22 December 2022

2220486

SECTION 4.55(1A) MODIFICATION APPLICATION – SSD 11564741 STAGE 1B (STAGE 5) SUBDIVISION, BARANGAROO SOUTH

Table 1 Proposed modifications (note the explanatory plans used to describe)

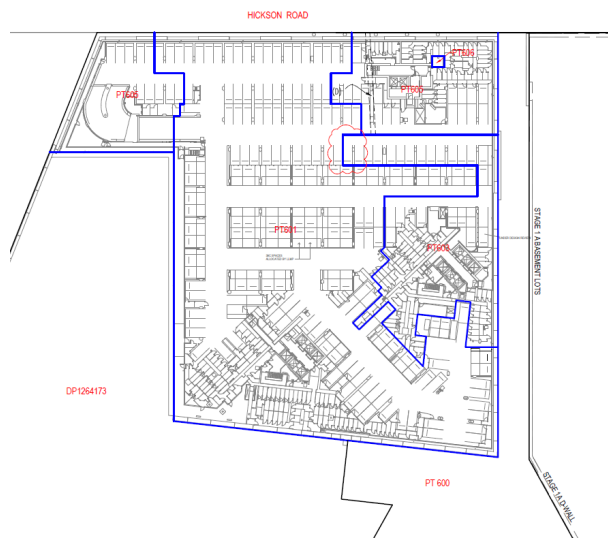
Lot number / location		
Stratum lot boundaries between Lot 605 and Lot 607 (in addition, 601 and 602, 601 and 603 as discussed below).	To reflect the proposed changes on Basement Level B0 being wall alignment, loading dock, storage and retail amenities (sought under separate modification application to Stage 1B Basement and Building R4A).	
Stratum lot boundaries between Lot 601 and 602	To reflect the proposed changes on Basement Level B1 regarding storage and amenities areas (sought under separate modification applications to Building R4A).	
Stratum lot boundaries between Lots 601 and 603	To reflect the proposed changes on Basement Level B1 regarding loading dock and storage areas (sought under separate modification applications to Stage 1B Basement, and Buildings R4A and R4B).	
Stratum lot boundaries between Lots 605 and 607.	To reflect reallocation of car parking spaces on Basement Level B1 within Building R5 lots (parking areas approved under Building R5).
